# UNITED STATES PATENT AND TRADEMARK OFFICE

## Office Action Summary

10/015,701

## DETAILED ACTION

**FIG. 3A**

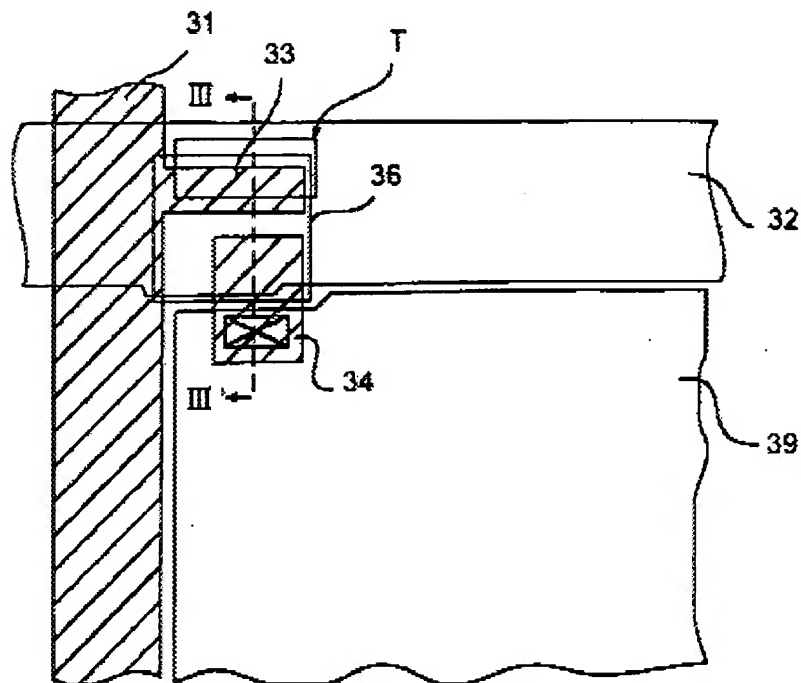
As to claims 1 and 7 Ohe discloses (Abstract and entire patent) a method of forming a liquid crystal display device comprising: forming an L-shaped thin film transistor (Figure 3A, col. 6, lines 32-37) and a pixel electrode, 39, on a first substrate.

**FIG. 5**

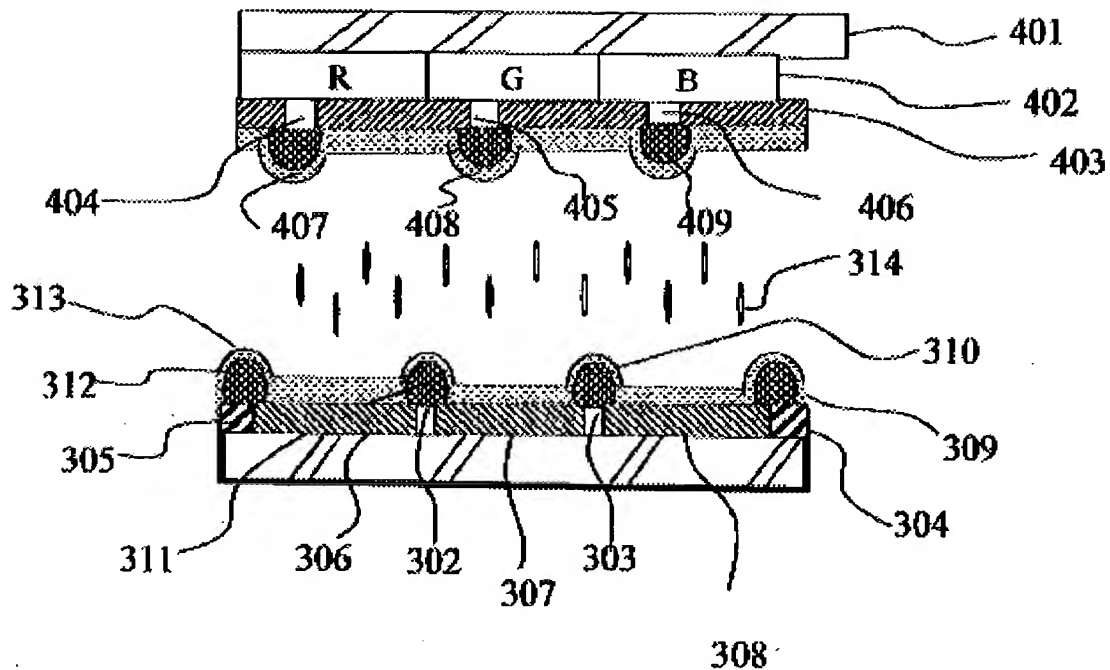
Liu teaches (Abstract and entire patent) forming bumps, 311 and 409 (Applicant's dielectric frame) on both substrates (Figure 5, col. 5, lines 45-57, and col. 5, lines 35-44) having a first height and a sealant having a second height (not shown) such that the sealant is taller than the dielectric frame as is evidenced by the gap between the dielectric frames and the opposed substrate (Figure 5) to comprise a multi-domain display with wide viewing angle (col. 2, lines 36-46).

As to claim 13, Liu, as combined above, teaches a method wherein the dielectric frame, 409, is formed on the common electrode, 403 (Figure 5).

As to claim 14, Liu, as combined above, teaches a method further comprising forming an alignment layer, 313 and 407, on the first and second substrates (Figure 5).

FIG.3

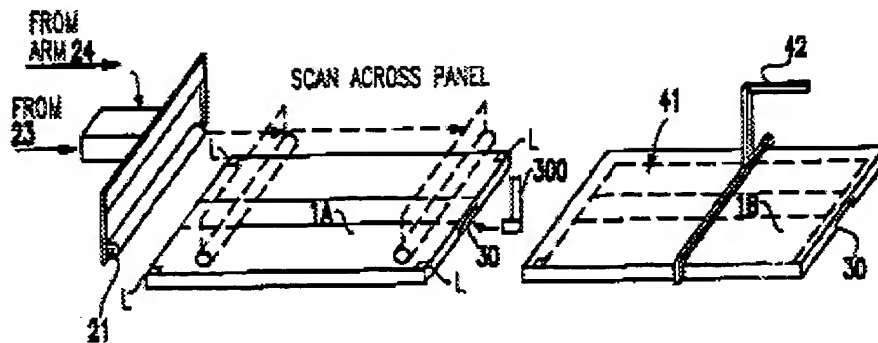
Von Gutfeld teaches dispensing liquid crystal on the first substrate (Abstract and entire patent); and attaching the first and second substrates to each other to provide a simplified and more efficient method for filling an unassembled LCD panel that is less costly (col. 2, lines 25-34).

**FIG. 2**

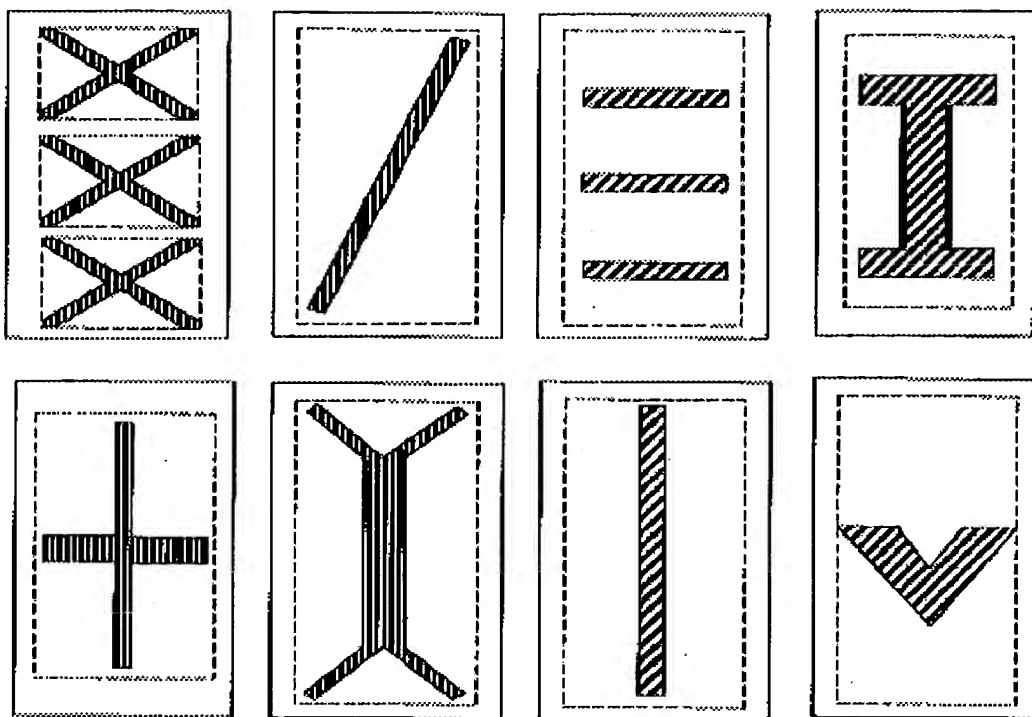
As to claim 5, Liu, as combined above, teaches in Figure 2 a method wherein the electric field inducing window has a slit shape or a hole shape.

**FIG. 1 (Prior Art)**

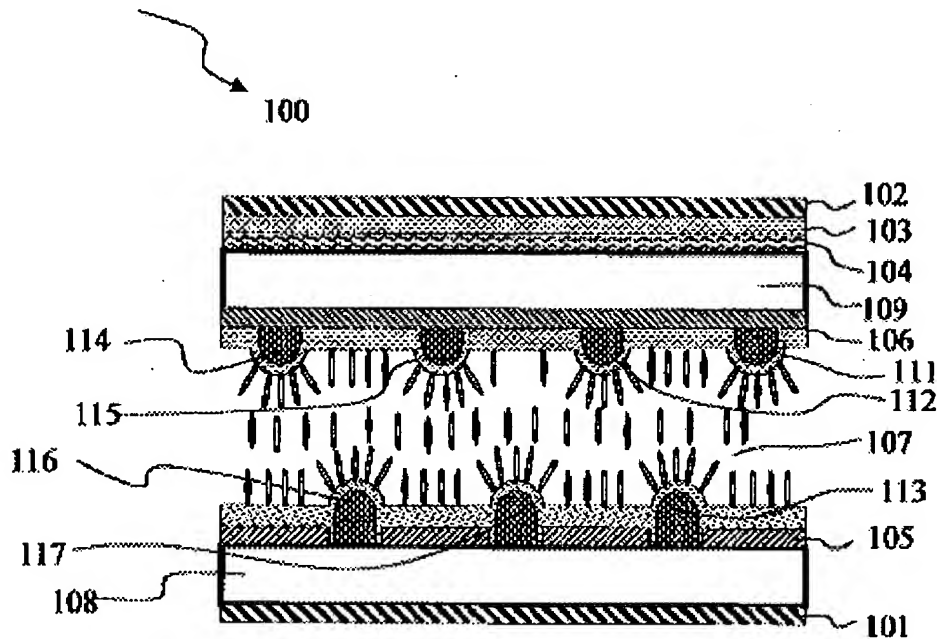
As to claim 9, Liu, as combined above, teaches Prior Art in Figure 1 that shows dielectric frames drive the liquid crystal in various directions.
